Interactive comment on “Development of an automated high temperature valveless injection system for on-line gas chromatography” by N. M. Kreisberg et al.

Received and published: 10 September 2014

Fig. 1. Figure 6

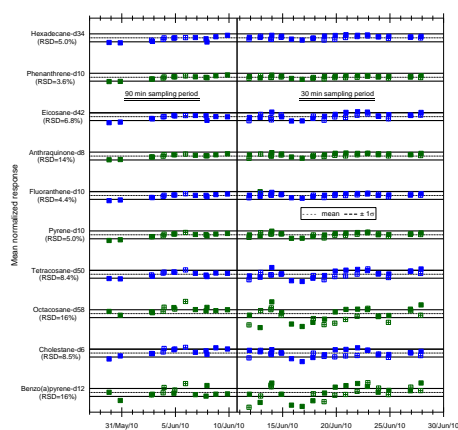
(iv) P. 7551, line 20-23: The argument underlying the effect of the vapor phase/gas-phase contribution is not well supported. Where are the data that show use of the carbon denuder?

To make explicit the two sub-sets of data in question, we have modified Figure 6 (uploaded separately) to include two types of symbols: open (denuded) and closed (non-denuded). The apparent dependence of response on sample size discussed in the text is now more easily seen in the plotted data. Explicit reference to the use of different symbols will be added to the text.
